**REACTOR VESSEL MATERIAL SURVEILLANCE
PROGRAM FOR INDIAN POINT UNIT NO. 2
ANALYSIS OF CAPSULE V**

**FINAL REPORT
SwRI Project No. 17-2108
(Revised)**

March 1990

FIGURE 1 PLAN VIEW OF IP-2 POOL

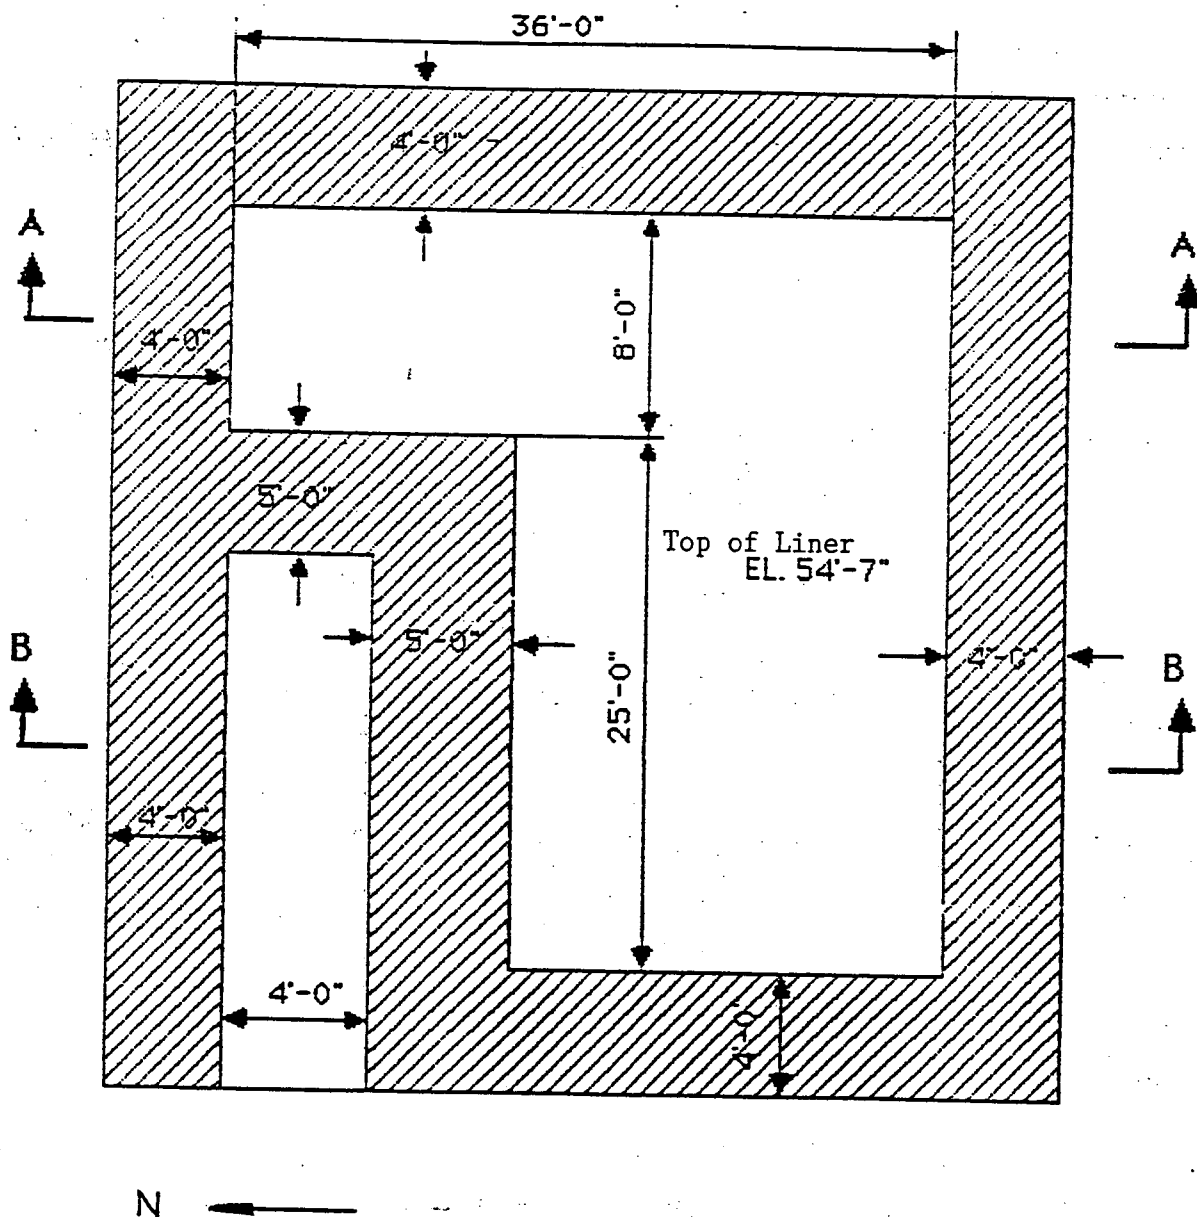
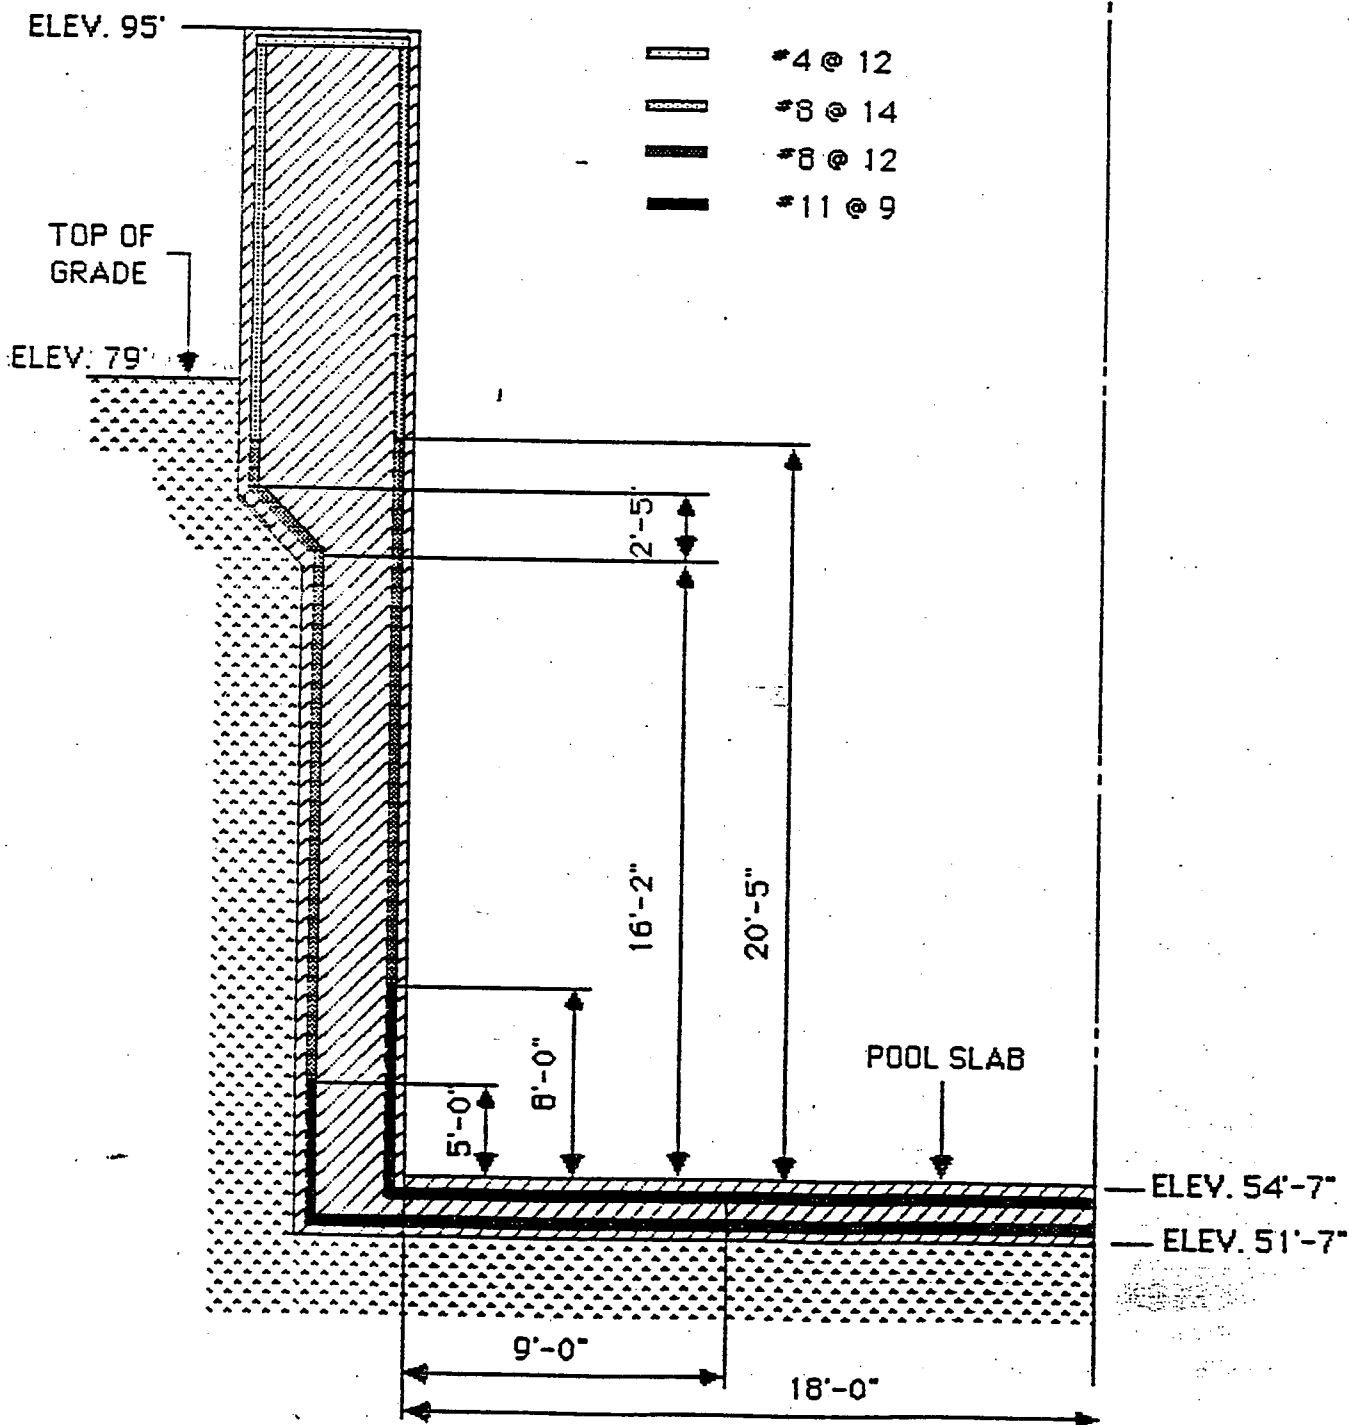
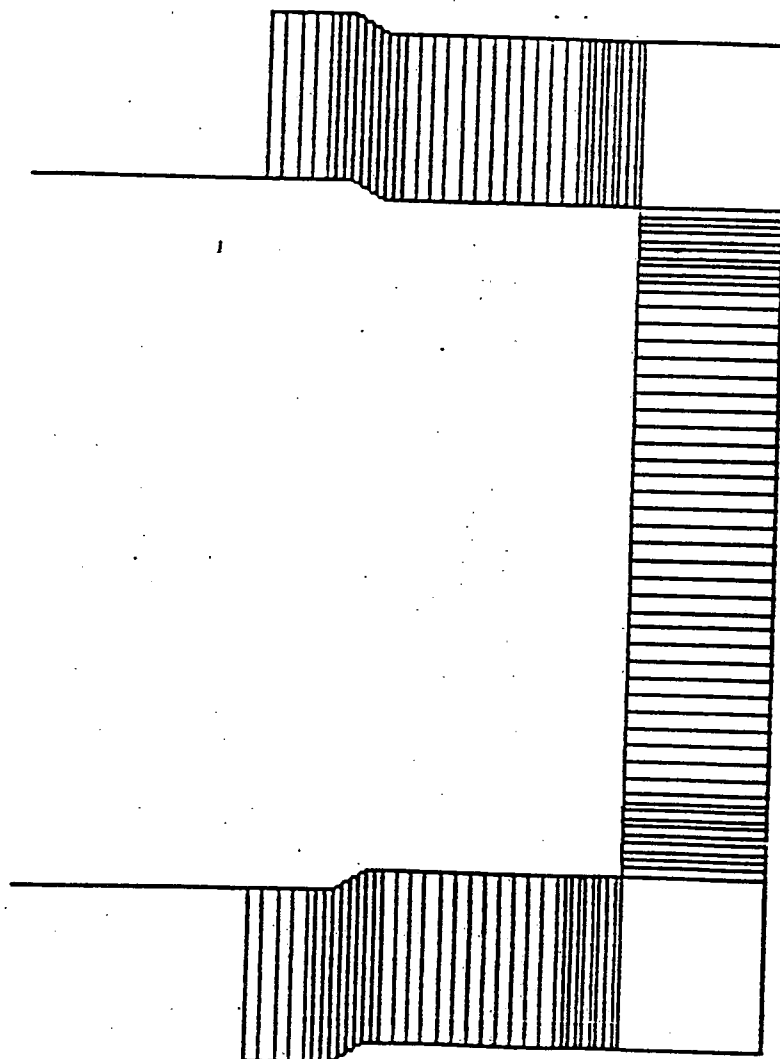
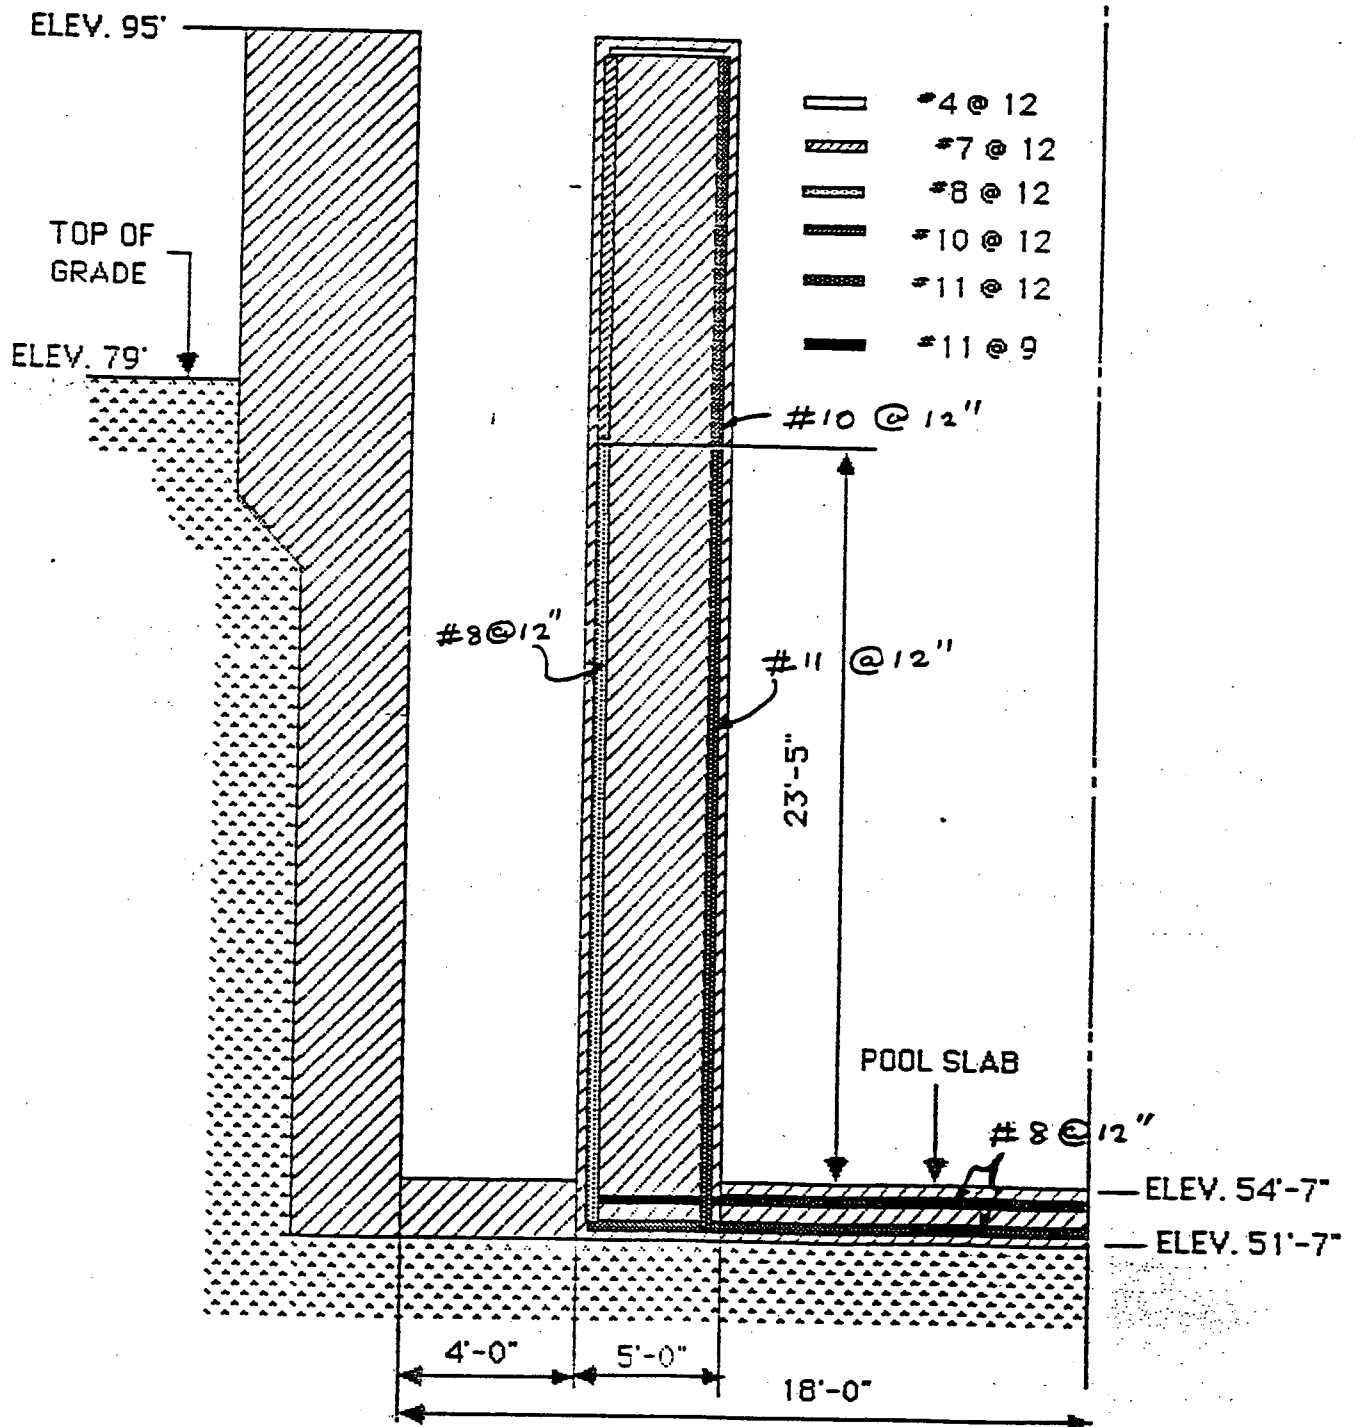
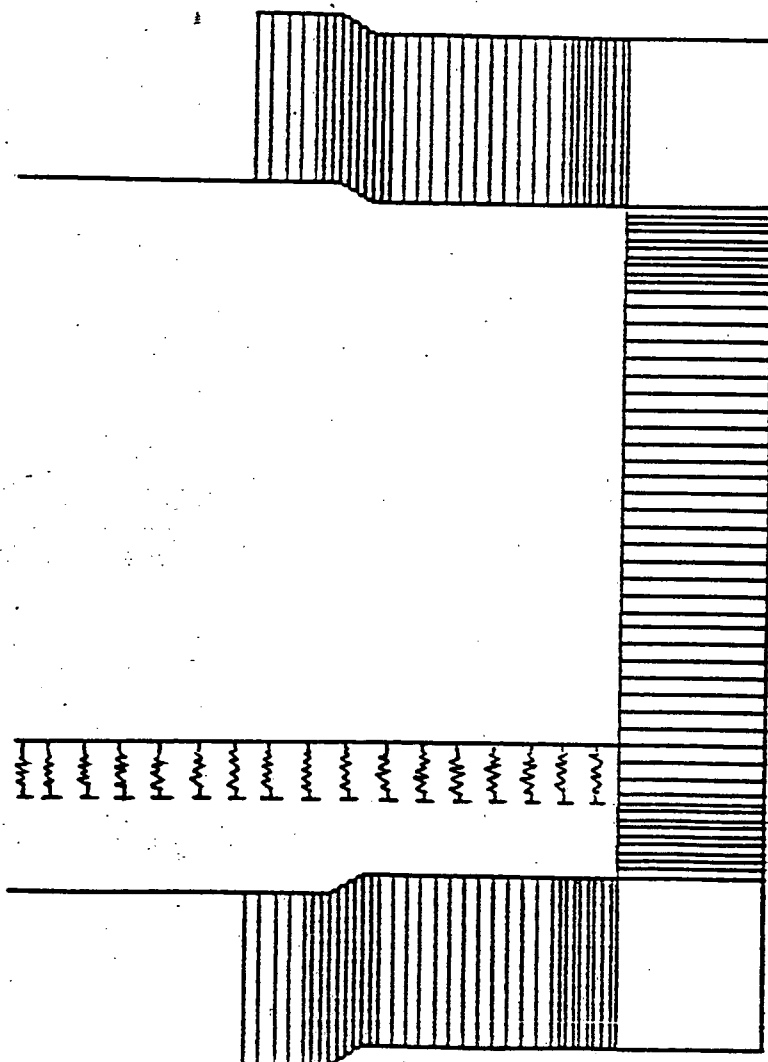
2. Provide information on how the additional weight of high density racks (HDRs) and impacts on floor and walls under the postulated seismic events are incorporated in the design of the pool structure. Provide information related to pool structure seismic responses (including hydrodynamic loads) due to the proposed reracking, controlling load combinations and stresses at critical structural sections.

The IP-2 Spent Fuel Pool is a reinforced concrete structure built on a rock foundation. The pool slab is 45 feet by 42 feet in plan and three feet in thickness. Referring to Figure 1, the pool floor is at elevation 54'-7". The load bearing (external) walls are 48" thick for the bottom 16'-2" above the pool slab, and increase to 75" thickness over a 2'-5" height. The thickness of the walls remains uniform (6'-3") for the remainder of the 20' of the top portion of the pool. The bottom 24'-5" (up to elevation 79'-0") of the pool walls and slab are below grade. Thus, from a structural standpoint, the pool slab and bottom 24'-5" of the pool walls are supported by a semi-infinite elastic continuum. The pool is filled with borated water up to the height of 39'-1". The size and location of reinforcement bars parallel to the plane of section are shown in Figure 2 for Section A-A and Figure 4 for Section B-B. It is noted that the top of the racks (which extend for approximately 178" from the pool liner) is well below the grade level.

The structural analysis is carried out using a finite element model of representative sections of the pool. The floor and walls are modeled using shell elements, and the foundation modeled using 3-D brick elements. Two sections were analyzed, denoted as Section A-A and Section B-B, respectively, in Figure 1. Figure 3 shows a 2-D slice of the fuel pit for Section A-A and the surrounding rock foundation. Section A-A is a sectional view parallel to the widest and weakest section. This section is assumed fully populated with the heaviest racks for structural analysis purposes.

Section B-B is chosen for analysis because it contains an internal pool wall (left wall in Figure 1) which does not have the lateral foundation support. Figure 4 shows the 2-D cut away section.

As noted previously, in order to obtain a conservative assessment of the stresses in the pool structure, the most controlling sections in the pool were analyzed using a Finite Element Model. The Finite Element Model consists of 270 elements and 544 nodes. Figure 4 shows the concrete sections modeled by shell elements. The contribution of the surrounding rack continuum is modeled using three dimensional solid elements. The following load combinations are per SRP 3.8.4.

FIGURE 6 CELL-WALL IMPACT CAPACITY
(UNIT DEPTH)

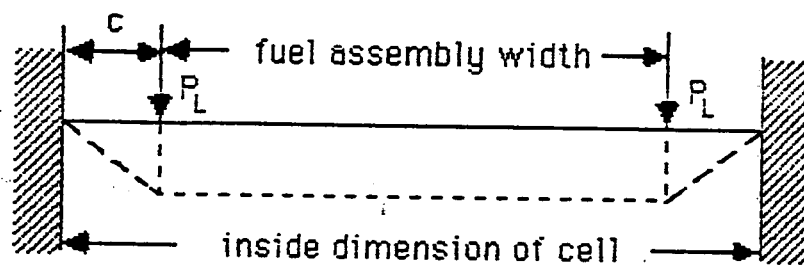
2. Provide calculations showing how the impact capacity (LAR Section 6.9.1) of cell-walls are estimated. Are the concurrent longitudinal stresses considered in combination with the stresses due to impact? What is the impact capacity of fuel assemblies?

The maximum fuel assembly-cell wall impact loads are calculated by DYNARACK and compared with the limit capacity of the section. Since these impact loads are localized, the only criteria is that collapse of the section does not occur. A beam section having length equal to the unsupported cell width and subject to two concentrated loads applied where the corners of the assembly would impact is analyzed for the limit state. The thickness of the beam section is .075". The actual impact load is compared to the limit load (with a safety factor of 2 built into the limit calculation). Figure 6 shows the configuration used for the impact load calculation.

The worst impact load on a cell is obtained from the DYNARACK computer code simulations as 424 lbs. Limit analysis applied to the configuration of Figure 6 yields

Concurrent longitudinal stresses are not considered in combination with impact load since these longitudinal primary stresses decrease with distance above the baseplate and are small in the region where maximum impacts occur.

The impact capacity of the fuel assemblies is approximately 5000 lbs. at each grid location, and an order of magnitude greater at other locations.
